Contract #: 04-0120F4Cty: SF/ALA Rte: 80 PM: 13.2/13.9File #: 69.25B**QUALITY ASSURANCE -- NON-CONFORMANCE REPORT****Location:** Changxing Island, Shanghai, P.R. China**Report No:** NCR-000766**Prime Contractor:** American Bridge/Fluor Enterprises, a JV**Date:** 14-Jun-2010**Submitting Contractor:** Zhenhua Port Machinery Company, Ltd (ZPMC), Changxing Island**NCR #:** ZPMC-0728**Type of problem:**

**Reference Description:** QA found an UT Indication after the contractor's had tested and accepted a weld for an Edge Plate to Stiffener weld in Segment 8CE

**Dear:** Mr. Charles Kanapicki  
**Job Name:** SAS Superstructure

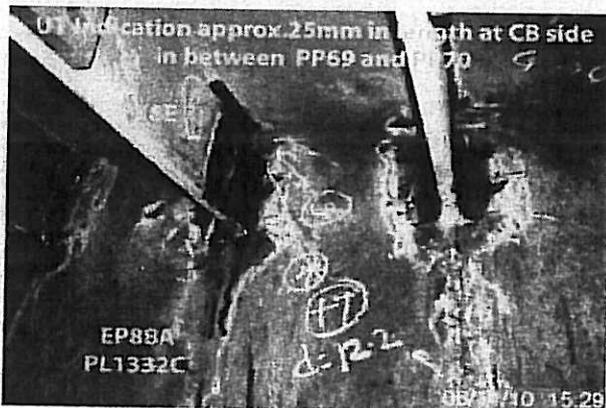
During the Quality Assurance (QA) Ultrasonic Testing (UT) review of welds located on Orthotropic Box Girder (OBG) segment 8CE, this QA Inspector discovered the following issues:

- One (1) longitudinal linear indication measuring approximately 25mm in length in the Complete Joint Penetration (CJP) "T" joint, joining Edge Plate EP88A (SPCM) to the under deck stiffener X8E.

- The indication D rating is +7.
- Material thickness is 25mm.
- The depth of the indication is approximately 13mm.
- The weld is identified as SEG048J-110 and is between panel point 69 and 70.

- The weld is designated as Seismic Performance Critical Material (SPCM).
- The indication is clearly marked near the weld.
- The Y distance for this indication was measured to be 5mm from the cope hole at the deck.

- Segment 8CE is located at Trial Assembly Yard.
- The Notice of Witness Inspection (NWIT) No. is 005977. The indication is located Within an area previously tested and accepted by ZPMC Quality Control (QC) personnel. As per the contract documents, ZPMC's QC personnel are required to perform hundred (100%) percent UT inspection of this weld.

ZPMC has removed and repaired the indication and is providing NDT documentation to show the weld is acceptable.
